Calgary

17 Avenue S.E. Corridor Study

Options Evaluation
Input Summary

Figure 4.87 – Cycle Track Carried Through an Intersection
 (Directional arrows should be applied within the cycle track)

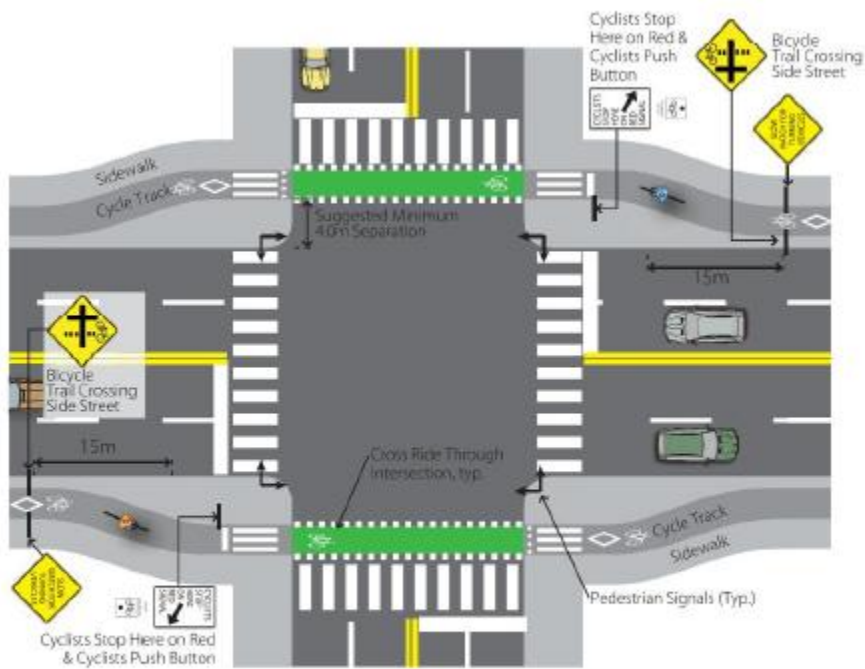
With any separated bicycle infrastructure, intersection treatments will be an essential consideration, both in terms of safety, due to the necessity for motorists to turn across the cycle track, and in terms of efficiency, where cyclists often must make dual-stage turns. A number of jurisdictions in North America have recently begun deploying protected intersections as a means to safely and efficiently promote cycle travel. Given that 17th Avenue SE is a greenfield corridor redevelopment and that both cycle track concepts are one-way, it may be possible to consider options for protected intersections here.

The following example is Figure 4.87 from Ontario's draft Book 18 Bicycle Facilities Manual (May, 2013) and shows an option for carrying one-way cycle tracks through an intersection, along with robust pedestrian crossing facilities.
